Report to the Independent Planning Commission (IPC) following the 23 January, 2024 site inspection

General question for consideration:

Does the Springvale Water Treatment Plant make a material difference to the water quality of the Coxs River catchment when the salt from that plant is placed on an unlined Ash Emplacement Area located above where the following image was taken in 2016?

Salt from groundwater emerging from the Western Coal Services site in 2016. This location is on the Castlereagh Highway, 250m north of where LDP001 crosses the highway [image by K Muir taken 9 April 2016, that is, before the Water Treatment Plant.]

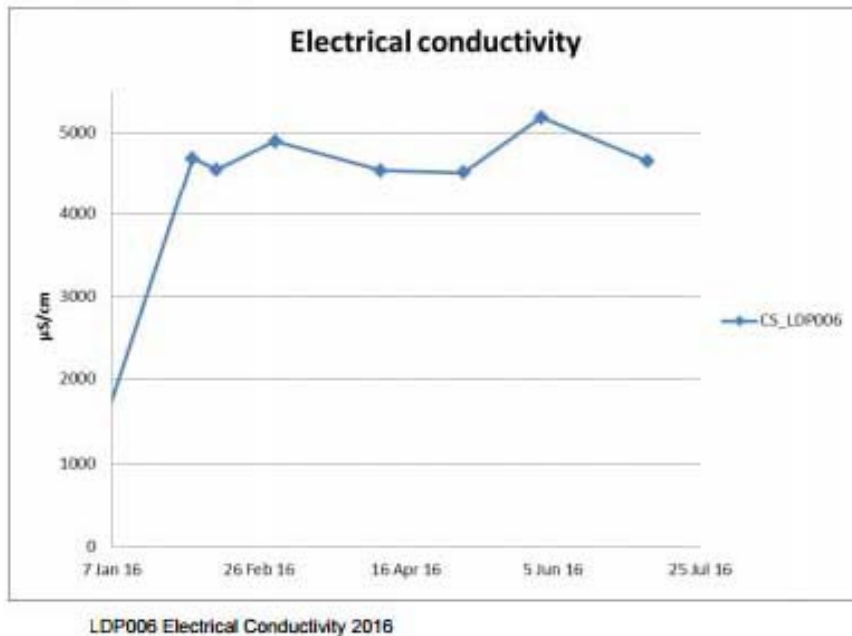
Recall how salt was observed on Tuesday emerging from the near the base of the reject emplacement area (REA) at the Western Coal Services (WCS) site on Tuesday's site inspection. Even the dewatered sediment sludge deposited in the REA does not prevent salt migration from this large, unlined REA that is open to the elements.

Underground and open cut coal mining covers the Western Coal Services (WCS) site and the fly ash-salt emplacement area. The light cross-hatching indicates the location of the bord and pillar mine workings.

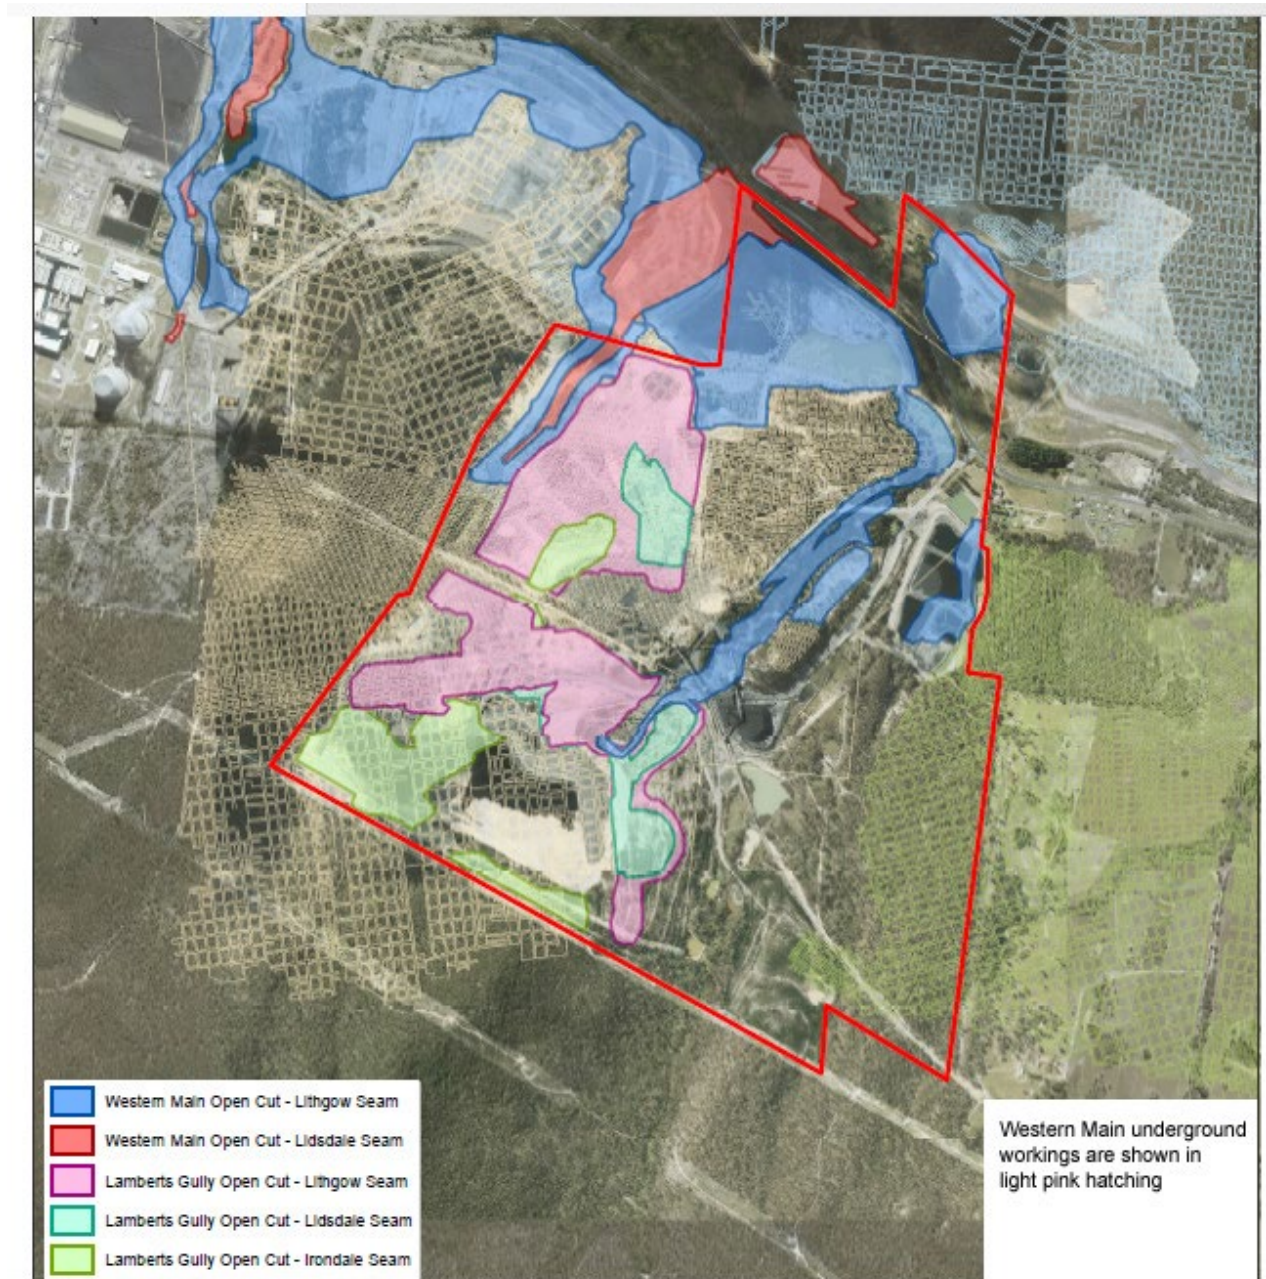
Taking the salt from the 42ML/day of mine waste and placing it on an unlined emplacement area is not going to lead to a neutral or beneficial effect on the Coxs River, particularly as the emplacement area lies above former coal mine workings (see figure, following page).

The waste emplacements on WCS site are unlined as are the fly ash-salt emplacement areas.

It is essential that saline groundwater draining from the WSC site and the fly ash-salt emplacement area are better controlled. Energy Australia's initial salt Interception project for the ash emplacement involved installation of boreholes to intercept that saline groundwater that had migrated off-site and to then pump it back to the ash repository. This approach was apparently unsuccessful. The current approach is to intercept the brine in groundwater below and around the ash repository and pump it to adjoining lined ponds (See [Mt Piper Brine in Ash Co-Placement | EnergyAustralia](#)).

Figure above indicates the relationship between the reject emplacement area, mined coal seams and Wangcol Creek [from WCS Mod 1 Statement of Environmental Effects, volume 2 Appendix D, figure 4.2 Nov 2015 regarding the groundwater model].

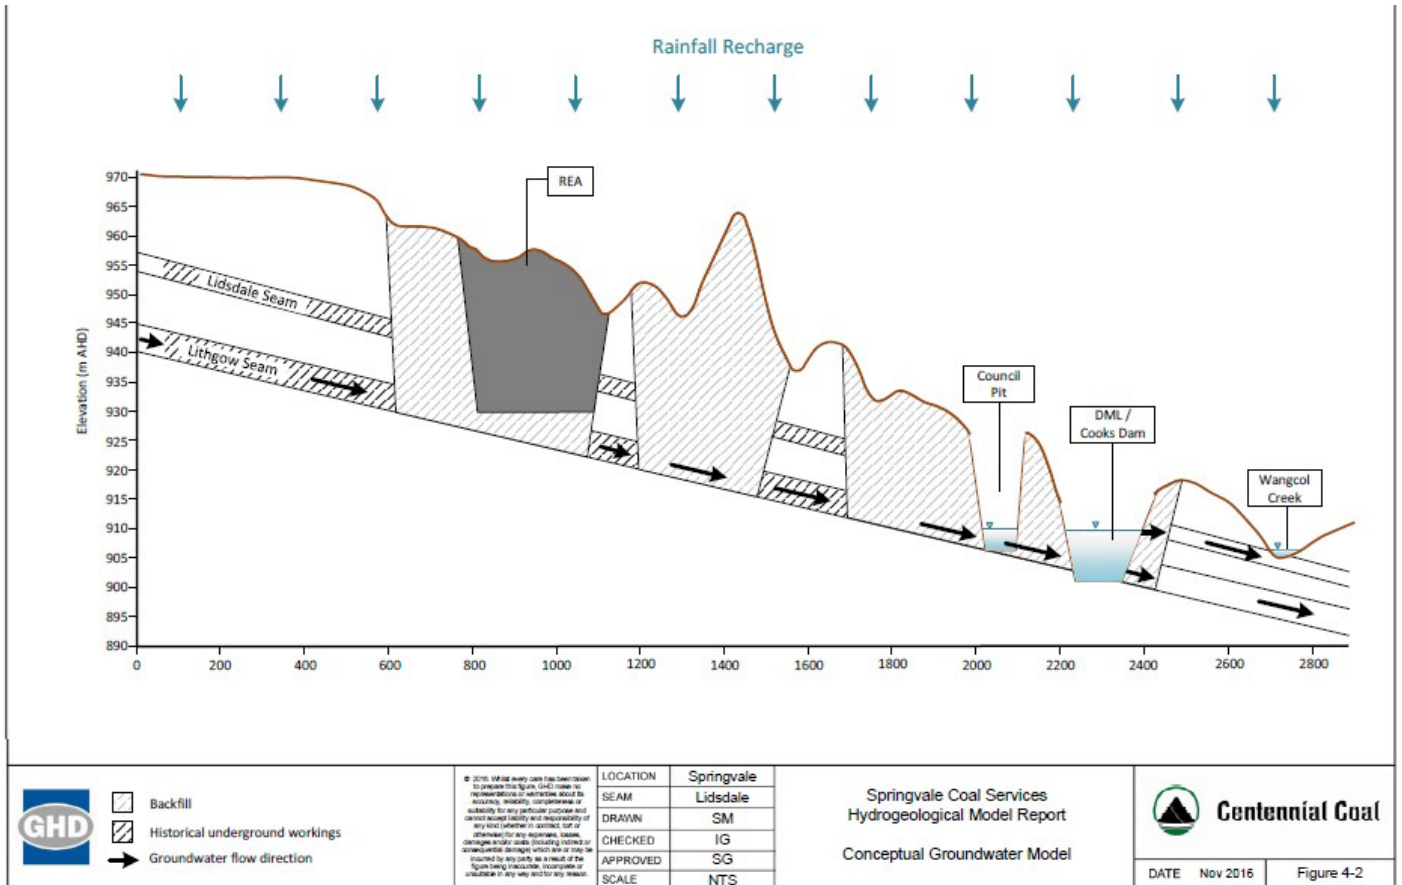
Non-point salinity pollution of Wangcol Creek by the emplacement areas at the WCS site and the fly ash and salt emplacement areas associated with the Springvale Water Treatment Plant is certain to increase over time towards the 2016 salinity levels recorded at LDP001 (LDP006).

Bord and pillar mine workings extend through in the coal seams indicated in the above GHD figure. These mine workings operate like an underground lake and mix the leachate from the Reject Emplacement Area [and the salt and fly ash emplacement area – not shown] to produce a large saline underground storage feeding Wangcol Creek, bottom right of GHD’s figure.

Figure 5-27 Groundwater level cross sections

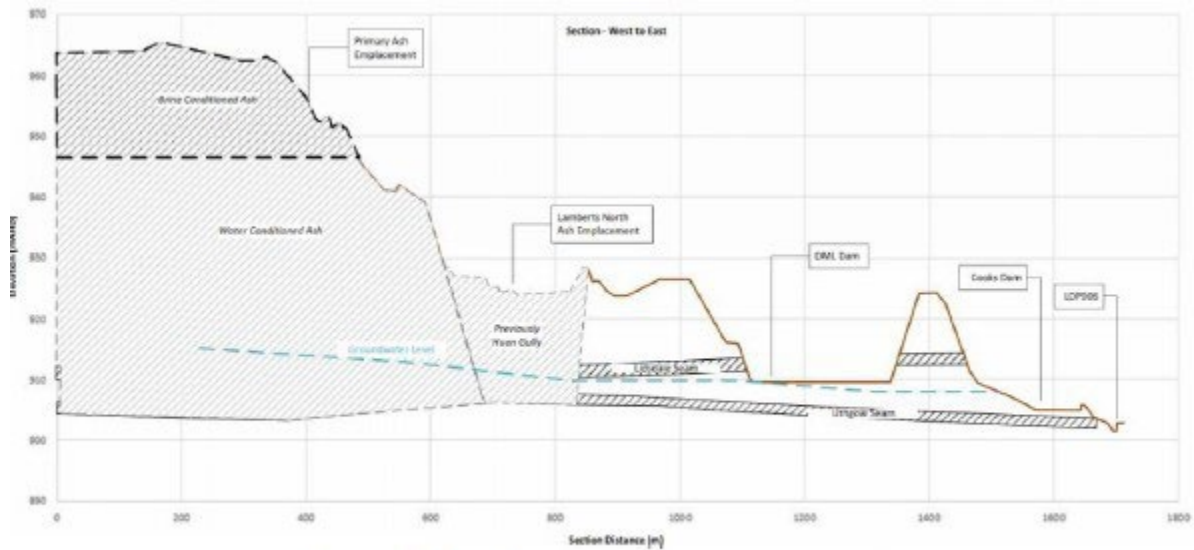
This figure indicates the relationship between the ash [and salt] emplacement area (left), ground water level in blue and LDP6 (now LDP001) (on right). It is a very poor arrangement.
